ADDENDUM NO. 1

December 26, 2023

**TO PROSPECTIVE BIDDERS UNDER
Fenter Rd Reconstruction
LVWD Bid No. 24-0105-02**

Sheet reference number:
Sheet 10 of 29

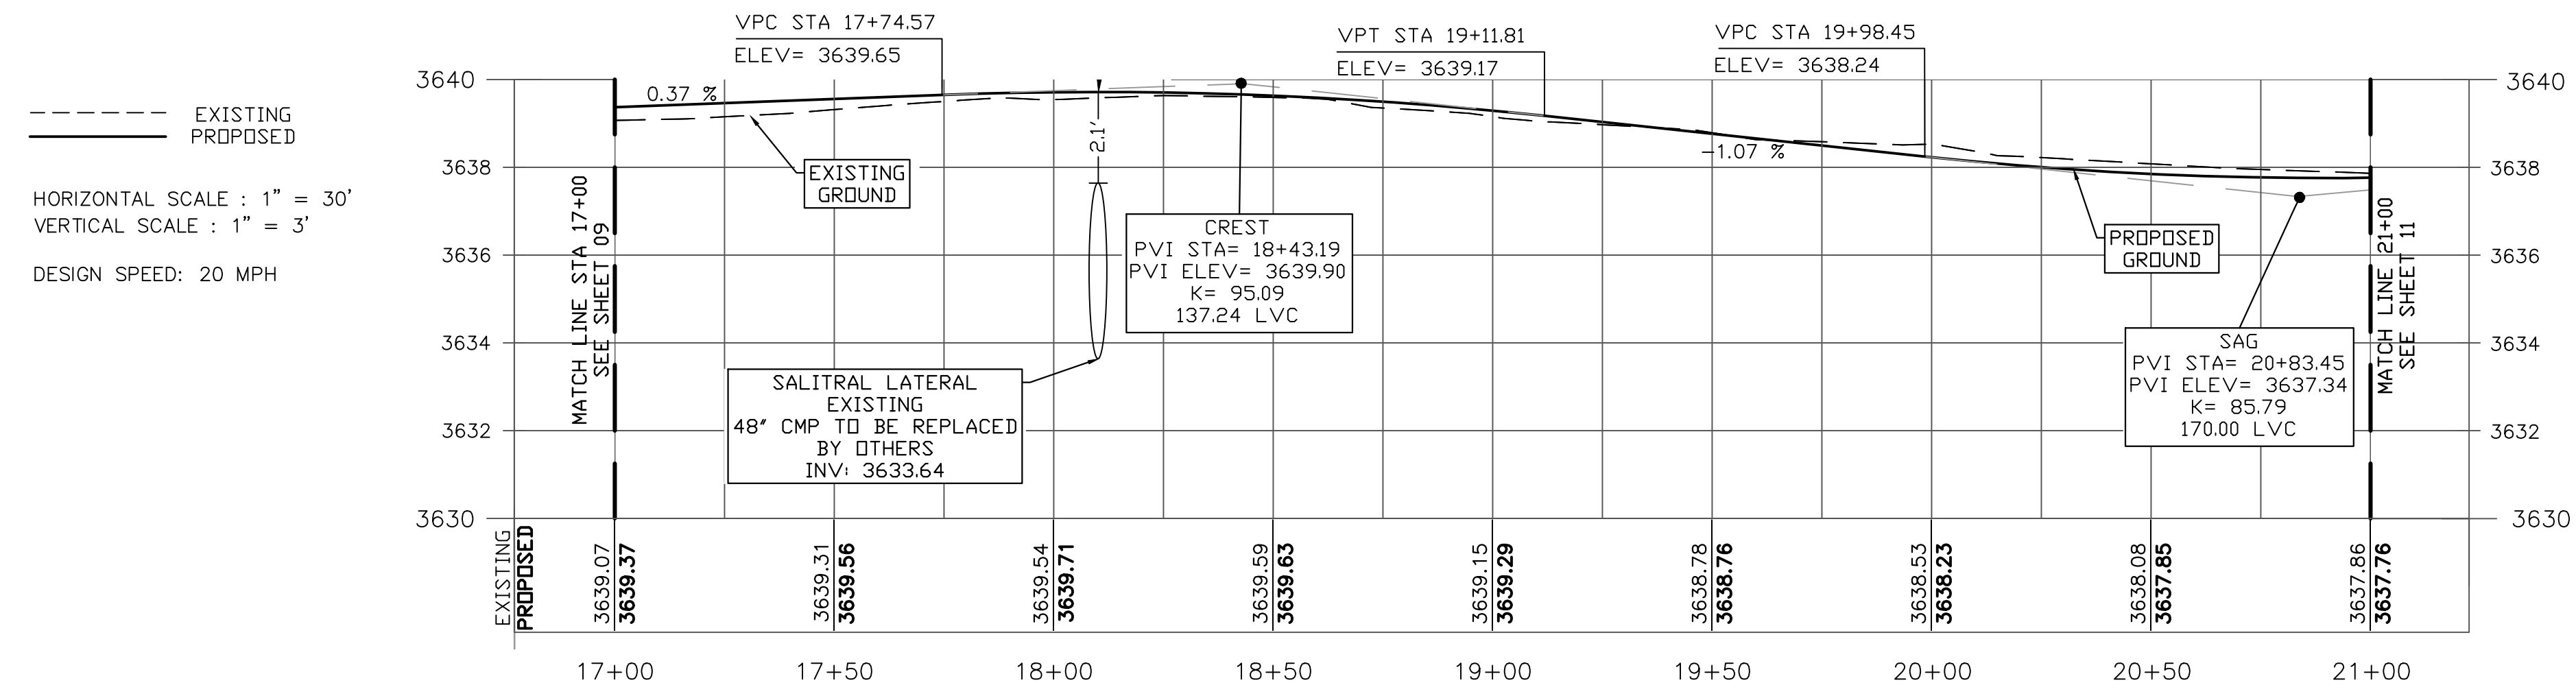
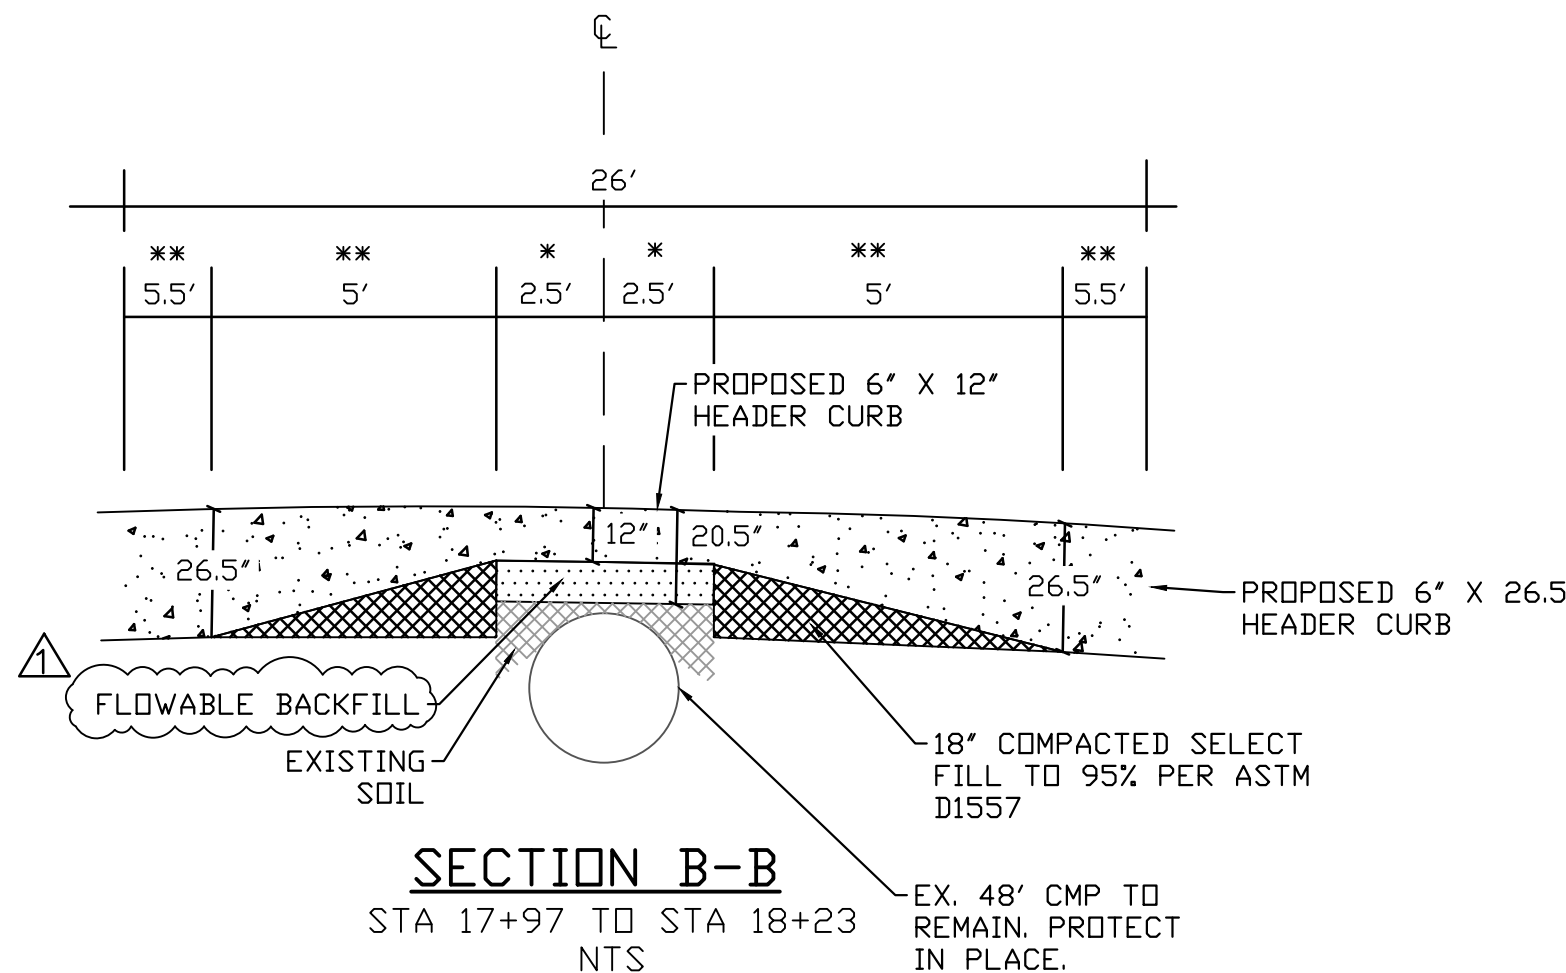
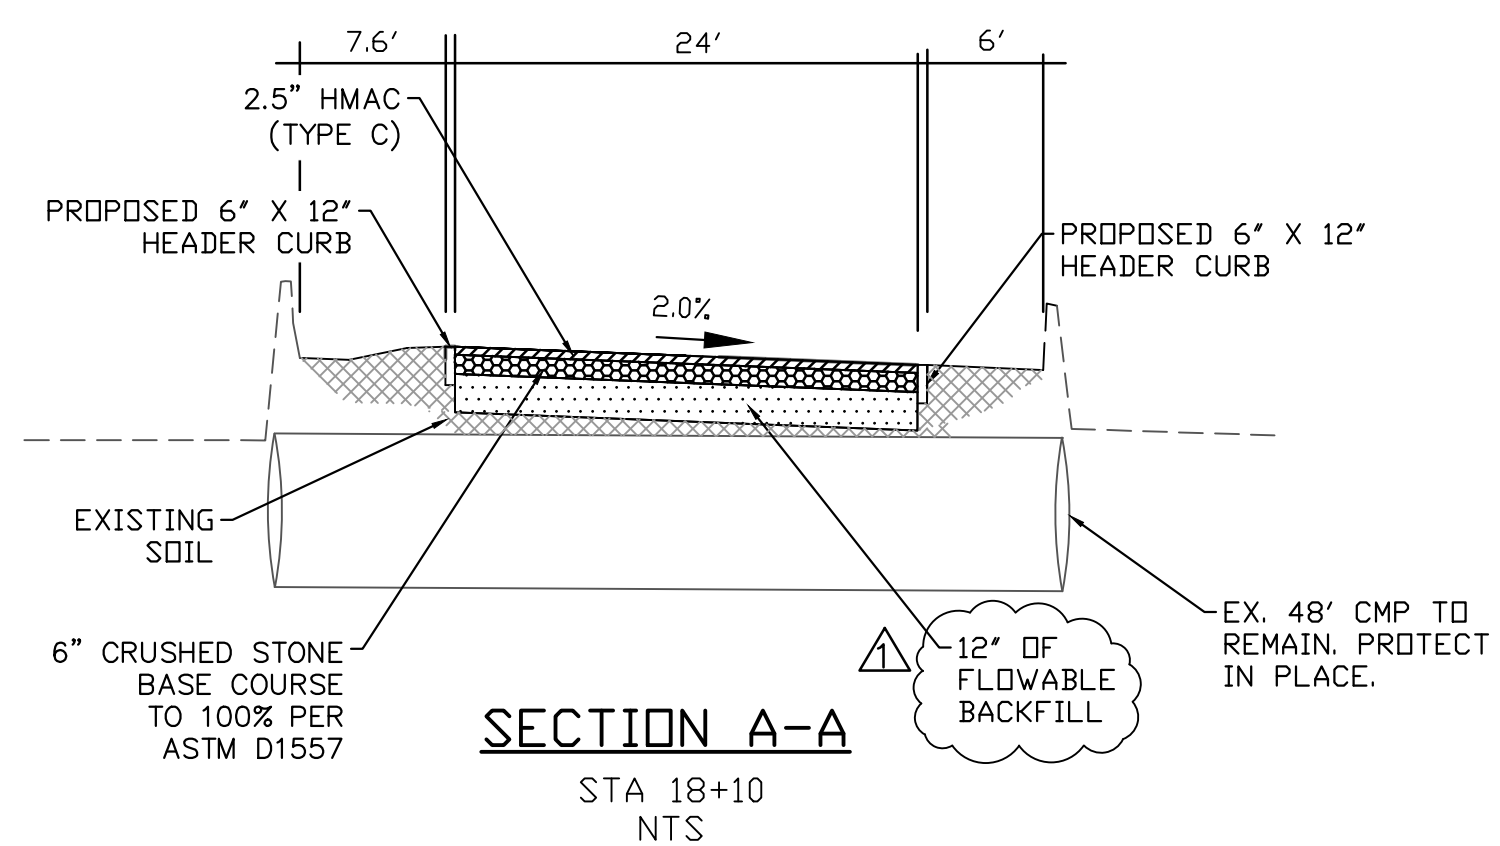
1.20	Sheet 10	<p>DELETE Sheet 10 in its entirety and REPLACE with Sheet 10 in Attachment 18.</p> <p>Revised Note 7, Section Note *, and callouts for Section A-A and Section B-B to reference flowable backfill, which will be required for the pavement section above the Salitral Lateral culvert.</p>

- SECTION NOTES:
- * CONTRACTOR SHALL PLACE 12" OF FLOWABLE BACKFILL BELOW BASE COURSE FOR A TOTAL 5' WIDTH, 2.5' TO EACH SIDE OF THE CULVERT FROM THE CENTERLINE. PAVEMENT STRUCTURE SHALL INCLUDE 2.5" OF HMAC, 6" OF CRUSHED STONE BASE COURSE, AND 12" OF FLOWABLE BACKFILL AS SHOWN IN SECTION A-A IN THIS SHEET. PRIOR TO PLACEMENT OF FLOWABLE BACKFILL, REMOVE LOOSE DEBRIS. DO NOT USE MECHANICAL COMPACTION DEVICES DIRECTLY OVER EXISTING PIPE.
 - ** PAVEMENT STRUCTURE SHALL INCLUDE 2.5" OF HMAC, 6" OF CRUSHED STONE BASE COURSE, 18" OF COMPACTED SELECT FILL, AND 8" OF COMPACTED SUBGRADE AS SHOWN IN THE CIVIL DETAILS SHEET.

Sheet reference number:
 Sheet 18 of 29

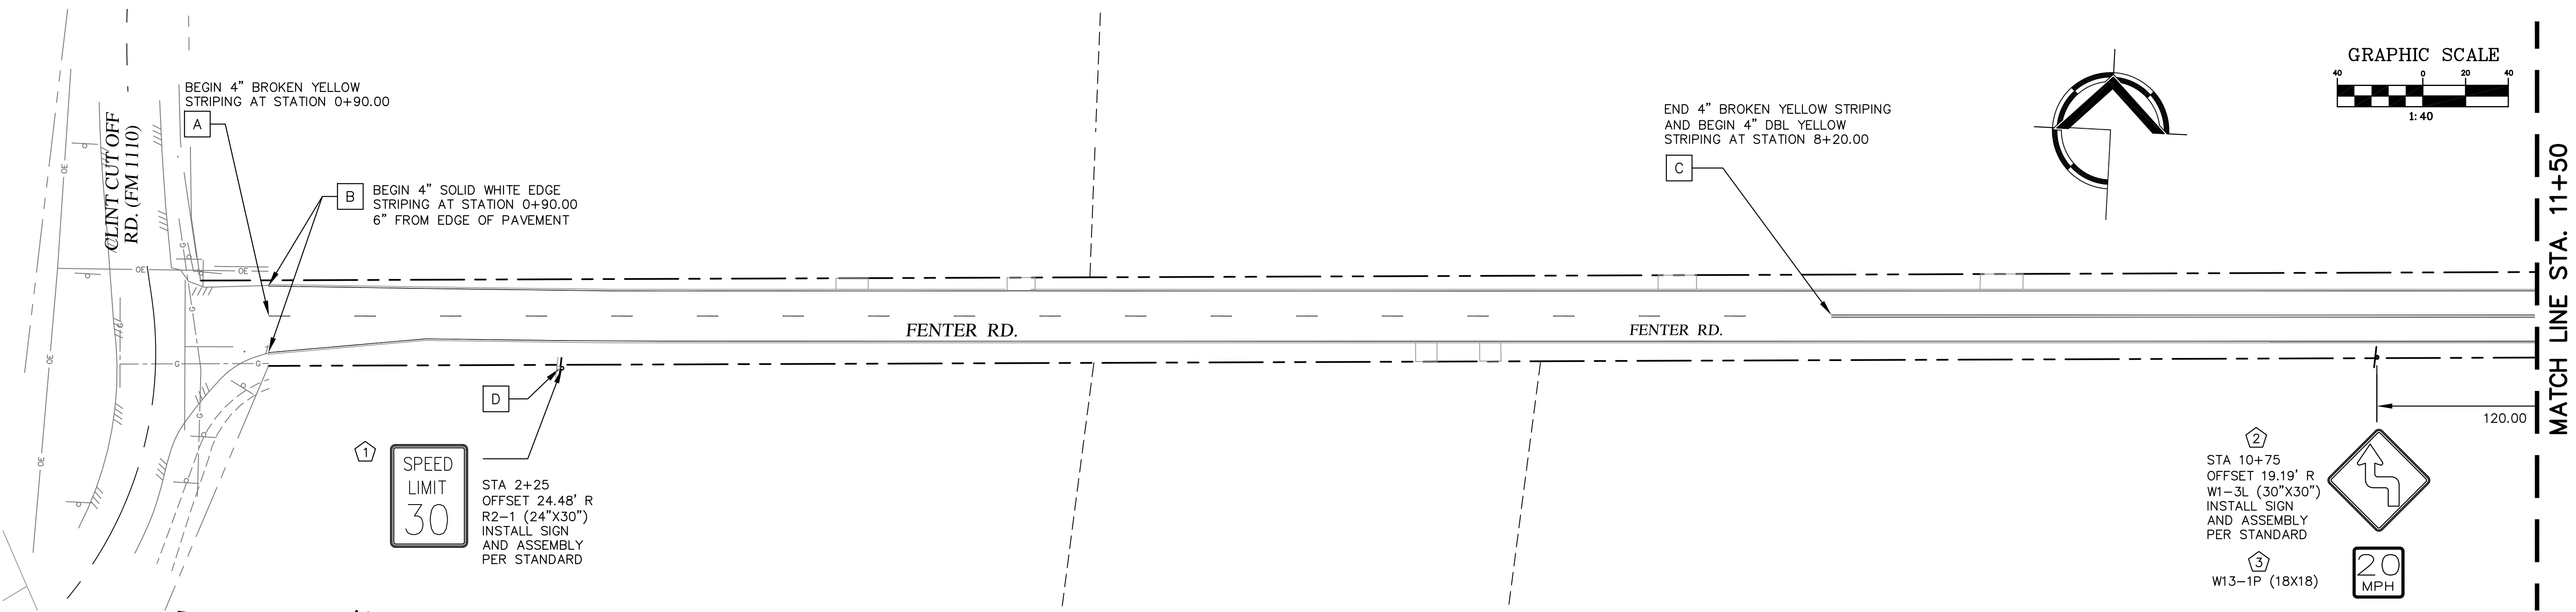
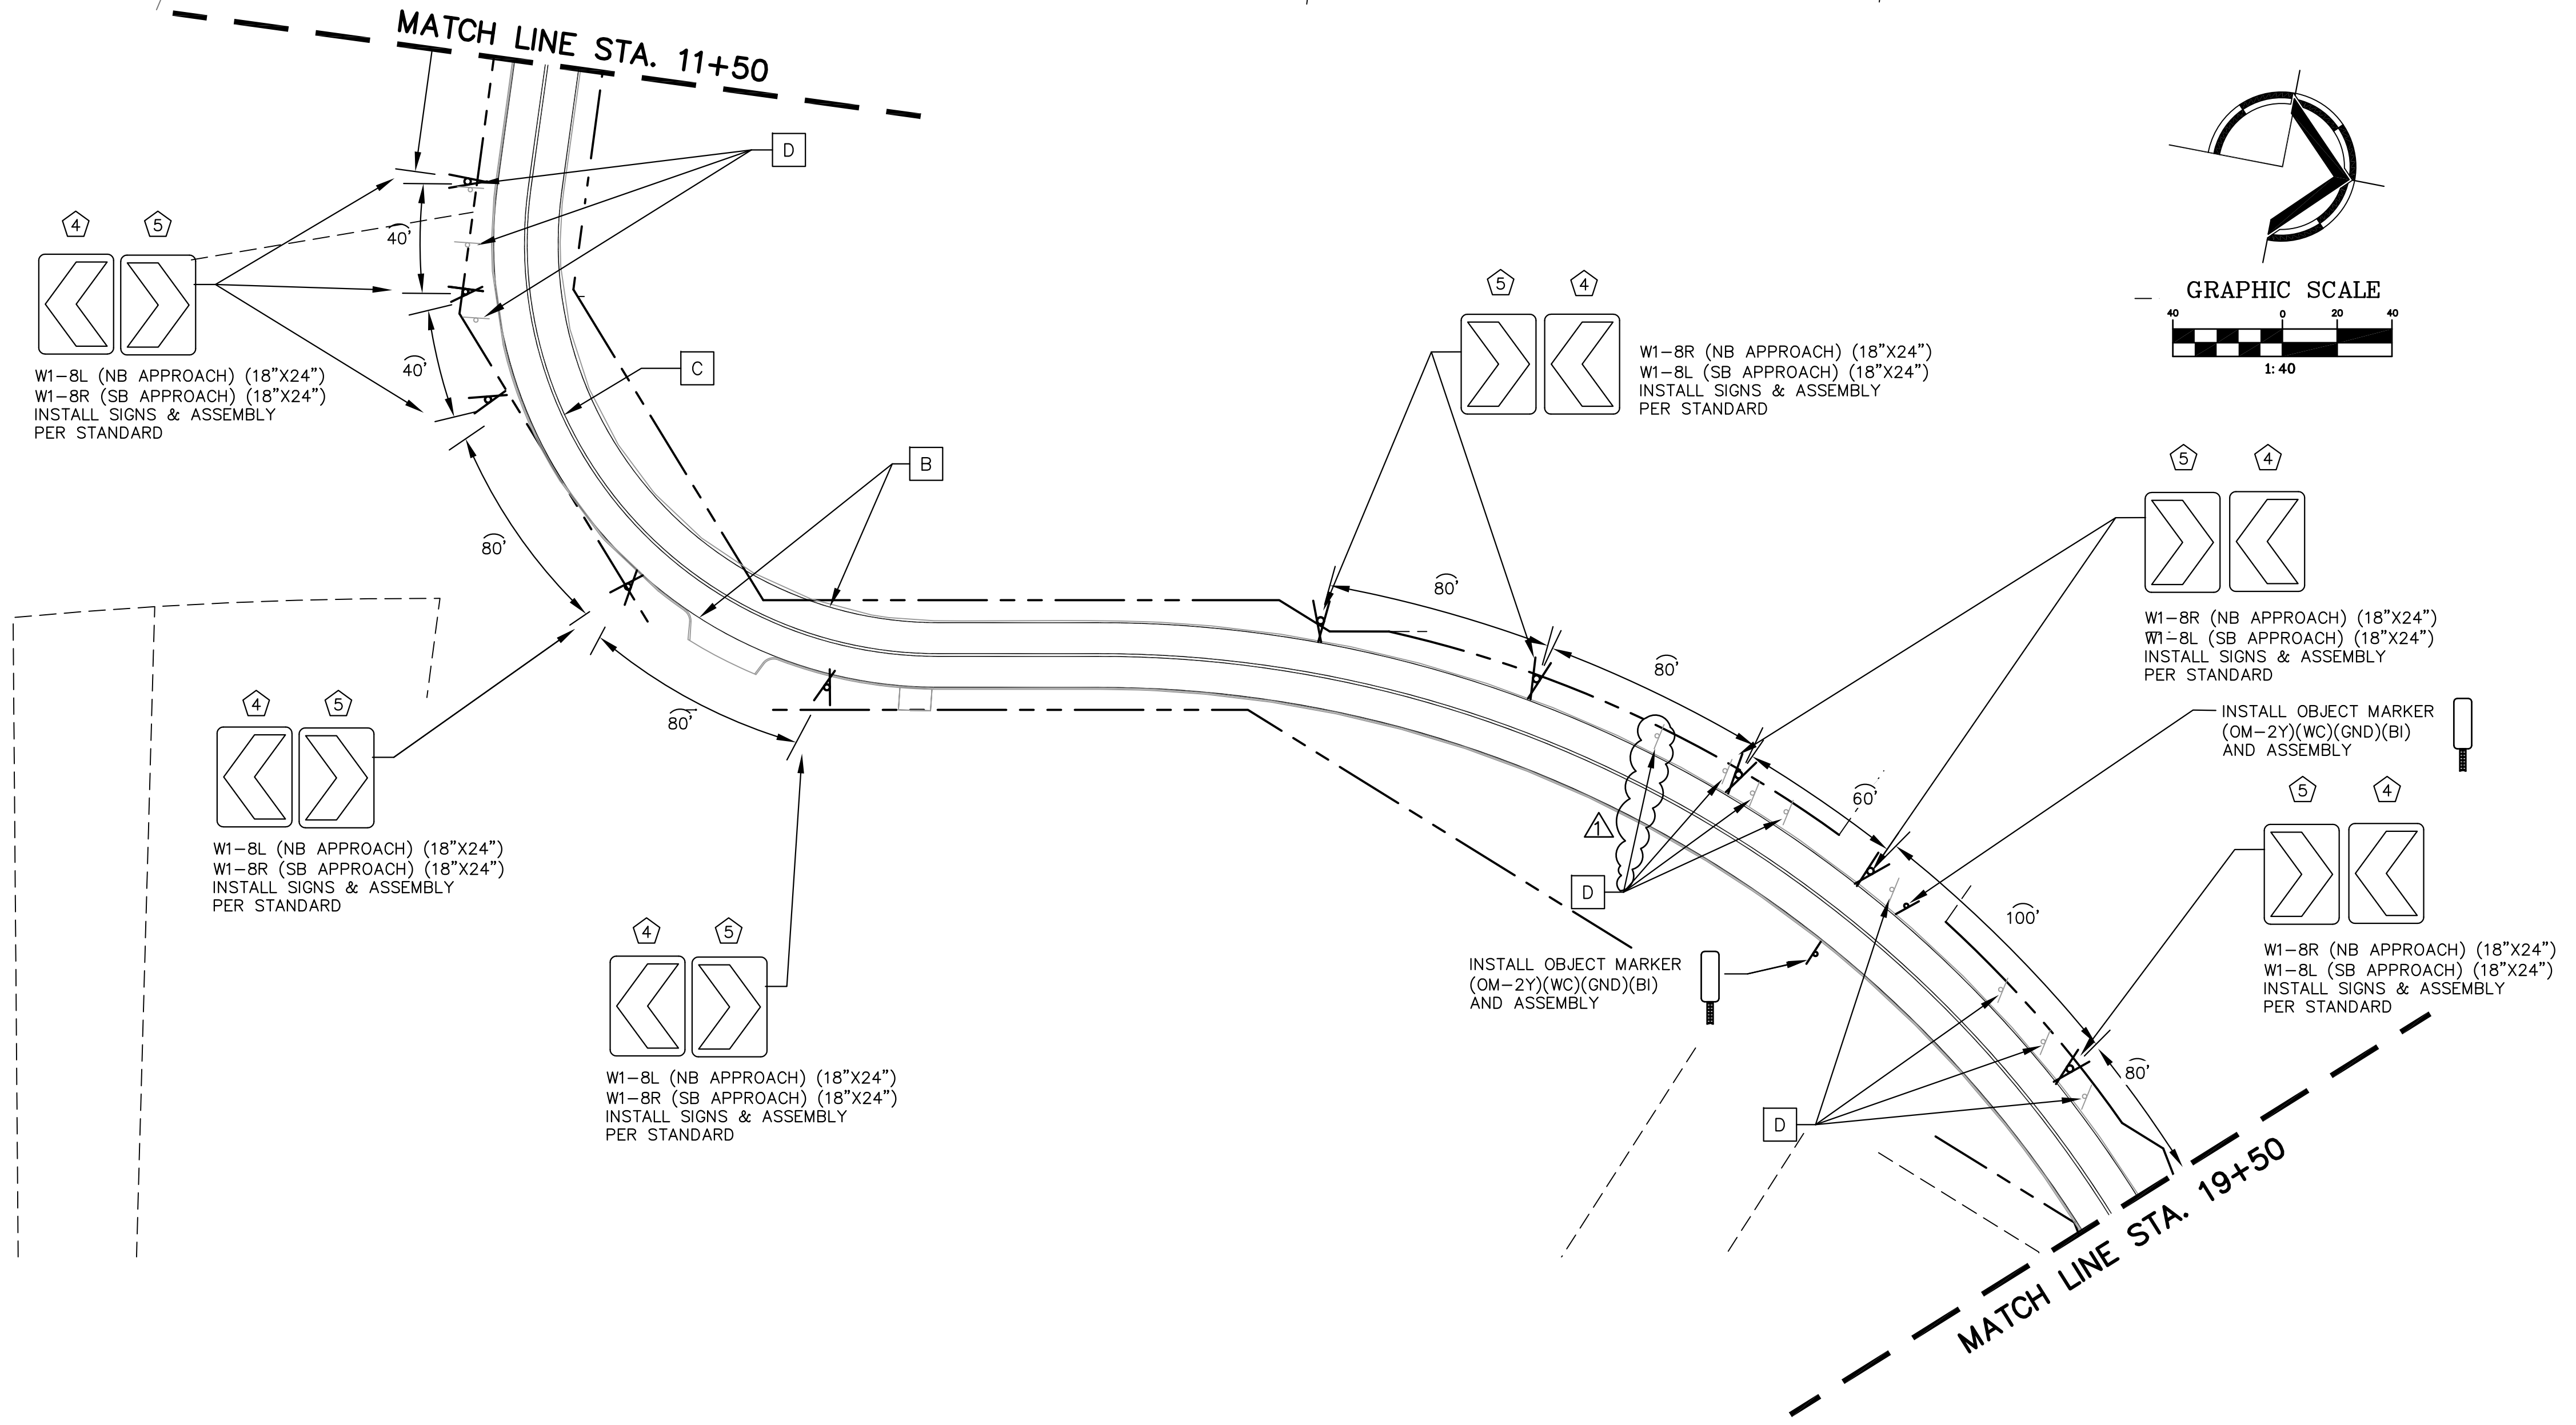
1.21	Sheet 18	<p>DELETE Sheet 18 in its entirety and REPLACE with Sheet 18 in Attachment 18.</p> <p>Added existing sign that was missing from original plans. This existing sign will be removed in this project.</p>
